APPLICATION NO.	FILING DATE	FIRST NAMED INVENTOR	ATTORNEY DOCKET NO.	CONFIRMATION NO.
10/718,056	11/20/2003	Koji Yamada	4041J-000812	9293
27572	7590	08/29/2006	[REDACTED]	EXAMINER
HARNESS, DICKEY & PIERCE, P.L.C. P.O. BOX 828 BLOOMFIELD HILLS, MI 48303				FORD, JOHN K
			[REDACTED]	ART UNIT
				PAPER NUMBER
				3753

Office Action Summary	Application No.	Applicant(s)	
	10/718,056	YAMADA ET AL.	
	Examiner John K. Ford	Art Unit 3753

An annotated picture of Figure 9 of this reference showing the component parts in relation to the claimed limitations is shown on the next page by way of explanation. It is submitted that this is somewhat clearer than a verbal explanation would be.

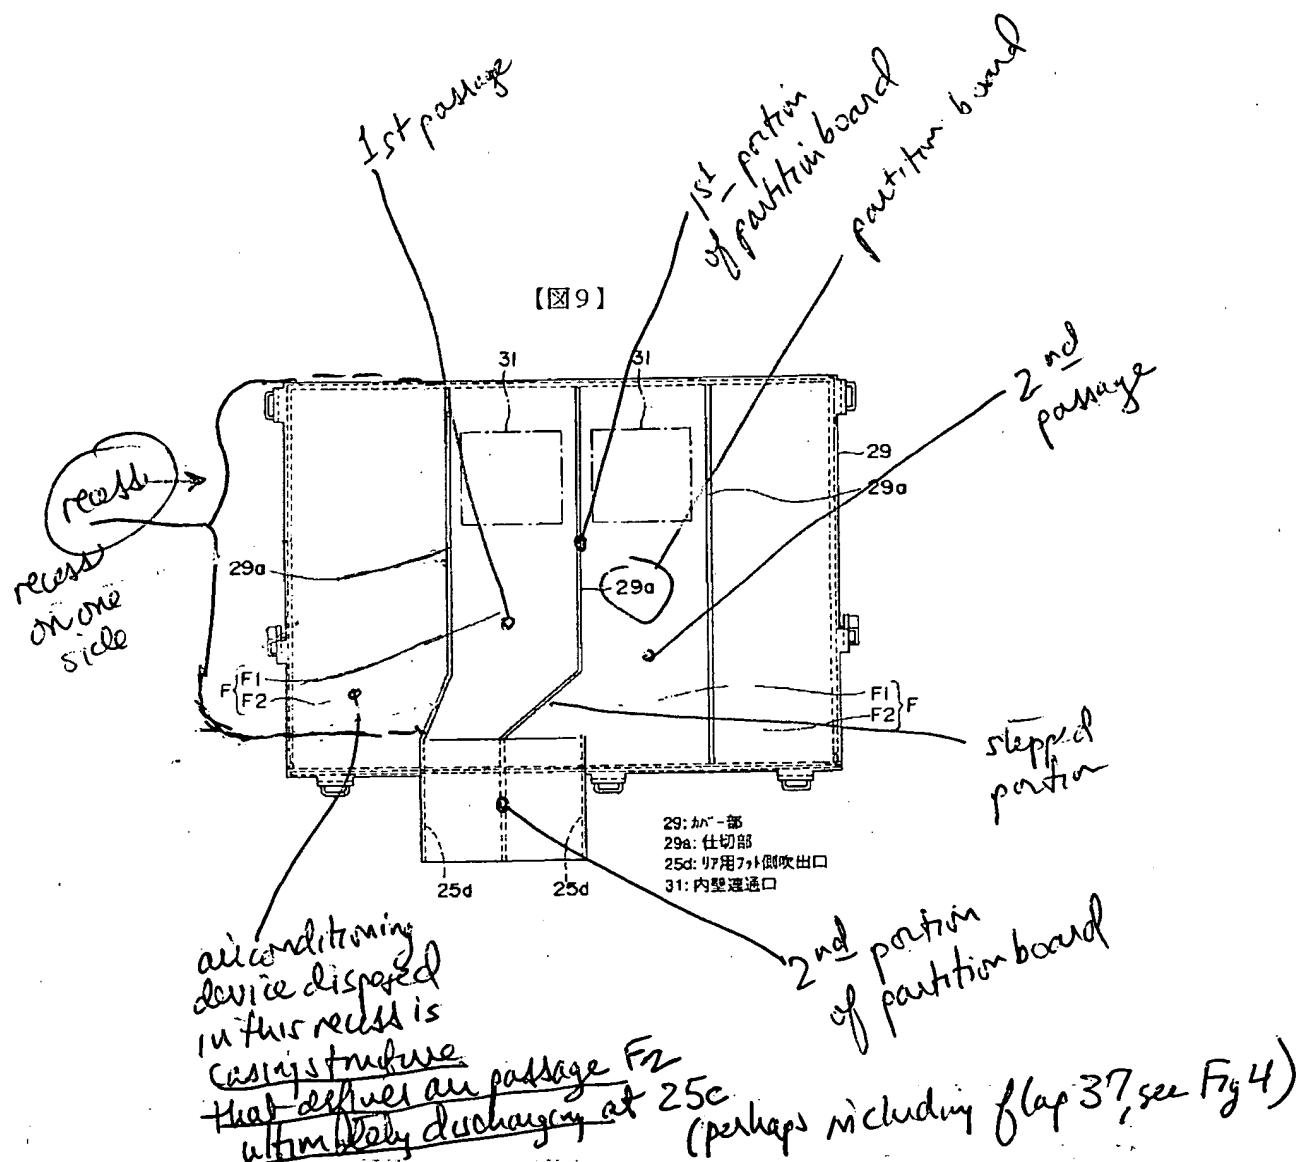
Claims 1, 10, 19, 20, 21 and 22 are rejected under 35 U.S.C. 102(b) as anticipated by or, in the alternative, under 35 U.S.C. 103(a) as obvious over JP 11-48753.
